Tehama-Colusa Canal Authority (TCCA) – Fish
Passage Improvement Project at Red Bluff Diversion Dam

Document Title: Pumping Plant and Fish Screen Project Hydraulics: Red Bluff Pumping Plant Fish Screen Hydraulic Model Study (1:42 Scale)

Quality Review Form (QRF)

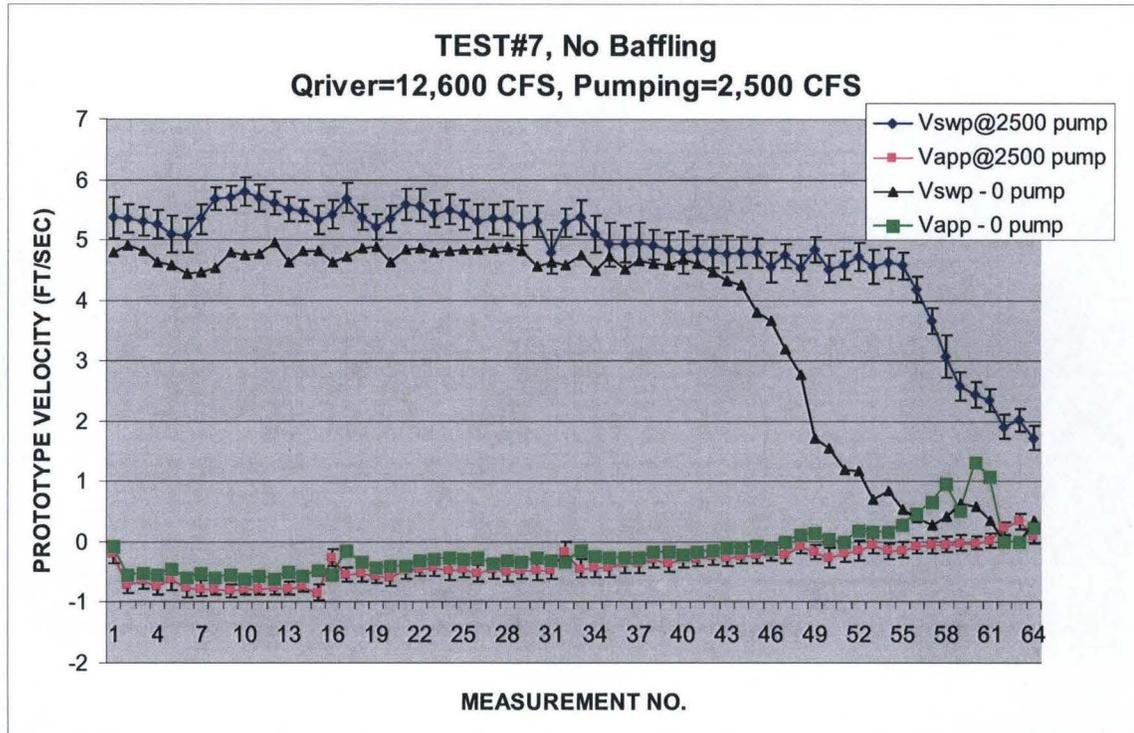
Page 12	Gatton	Figure 9 point out that + is downstream and away from the screen. The negative approach velocities are a bit confusing. Also from a terminology point of view we refer to them as "blowout bays" not "3 bypass panels".	C	TVermeiden	Added two sentences on pages 9 and 11 describing the 2-D velocity vector orientation. Change completed 8/17/2009	
Page 12	Gatton	On the paragraph "Fish Screen Baffling" I have the same comment as on page 5 above.	F	TVermeiden	See page 5 response.	
Page 13	Gatton	Figure 10 has the same comments as Figure 9.	C	TVermeiden	Added two sentences on pages 9 and 11 describing the velocity vector orientation. Change completed 8/17/2009	
Page 5	Thomas	Velocities in the approach channel are referred to as "approach velocity" which can be confused with velocities normal to the fish screen. Please consider replacing "approach velocity" with "approach channel velocity."	C	TVermeiden	Change completed 8/17/2009
